**SUBJECT: CHANGES TO TECHNICAL SPECIFICATIONS TO ADD A TRANSFER SWITCH
AND MAKE ADMINISTRATIVE CHANGES TO CORRECT ERRORS**

RE: GRAND GULF NUCLEAR STATION, UNIT 1

Amendment No. 19
License No. NPF-29

SUPPORTING AMENDMENT NO. 19 TO FACILITY OPERATING LICENSE NO. NPF-29

FIGURE 5.1.1-1
EXCLUSION AREA AND GASEOUS EFFLUENT RELEASE POINTS

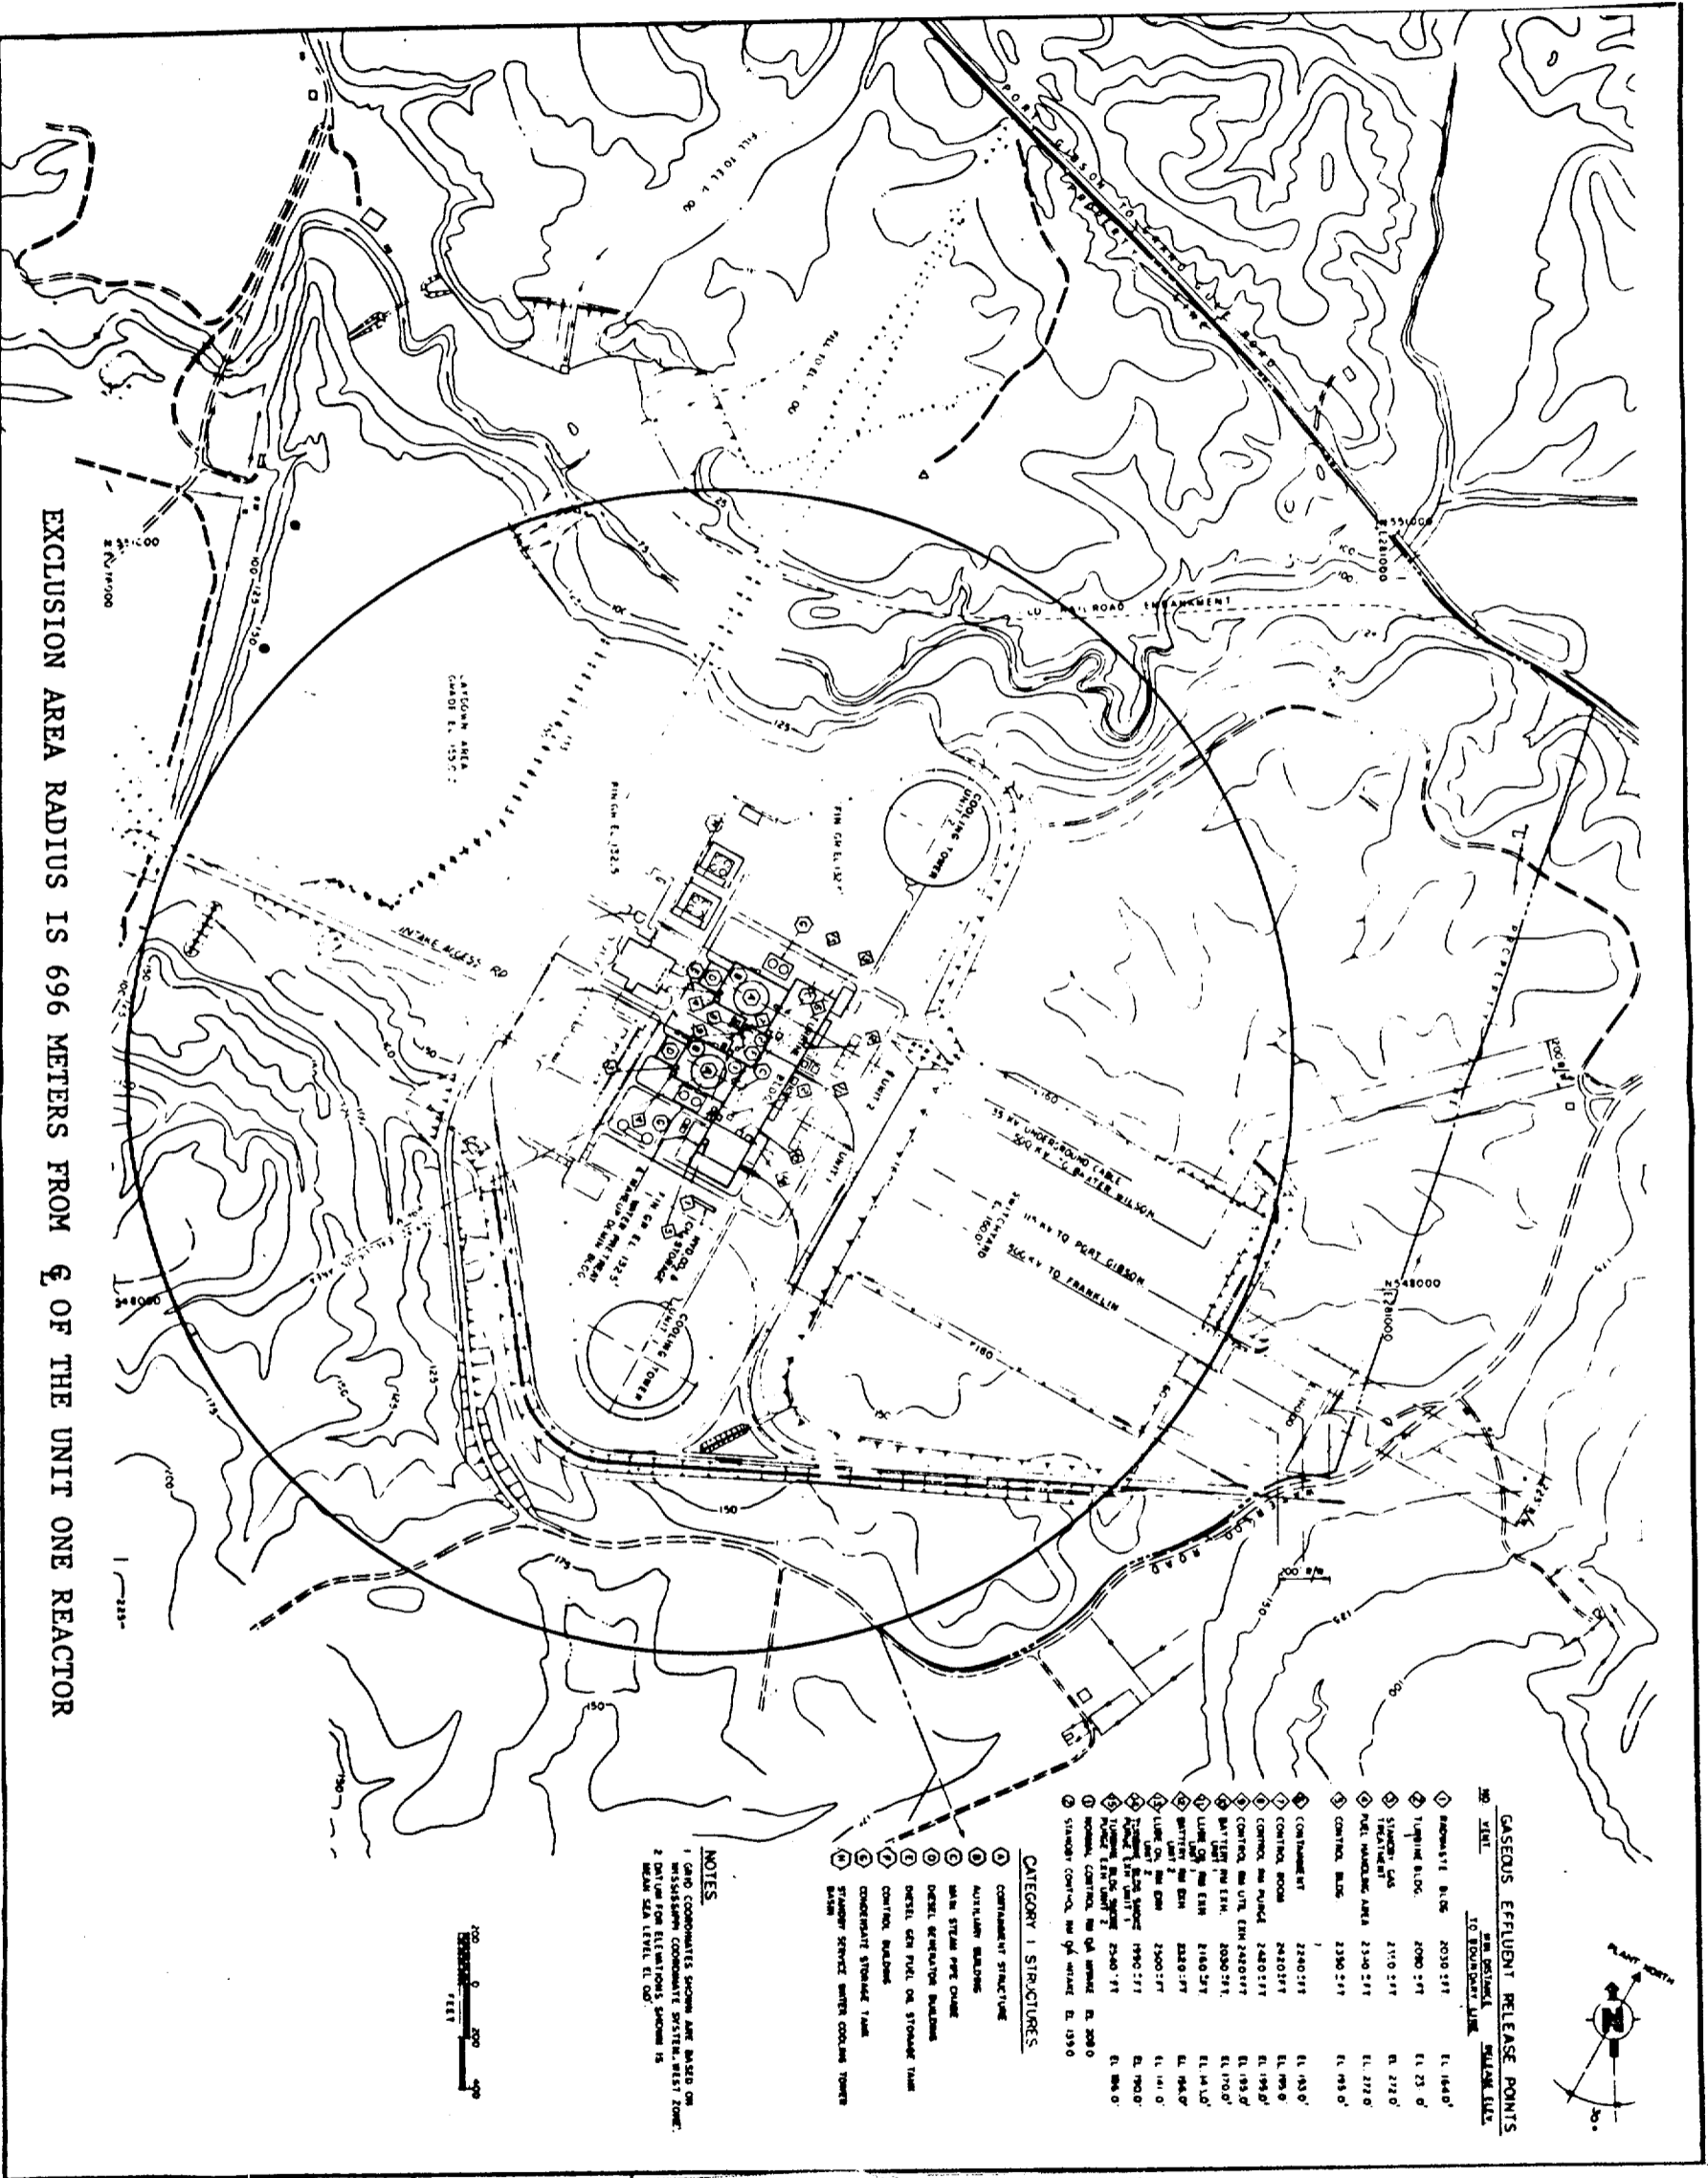
Figure 5.1.1-1 of the Technical Specifications is intended to identify the exclusion area and gaseous effluent release points for Grand Gulf Nuclear Station (GGNS), Unit 1. As currently depicted in Figure 5.1.1-1, the northern half of the exclusion area for Grand Gulf Unit 1 is centered on the Unit 2 reactor, and the southern half of the exclusion area is centered on the Unit 1 reactor. The minimum exclusion area boundary distance is 696 meters. The licensee has proposed to replace the current envelope of the exclusion areas for both reactors with an exclusion area for Grand Gulf Unit 1 centered solely on the Unit 1 reactor with a radius of 696 meters. For operation of Unit 1 only, the proposed change will not affect the results and conclusions presented in Section 11.2.2 Gaseous Waste Treatment System and Section 15.3, Radiological Consequences of Design Basis Accidents, of our Safety Evaluation Report (NUREG-0831, dated September, 1986) which assumed a minimum exclusion area boundary distance for the Technical Specifications for GGNS Unit 1, since Unit 2 is not in operation.

EXCLUSION AREA RADIUS IS 696 METERS FROM \odot OF THE UNIT ONE REACTOR
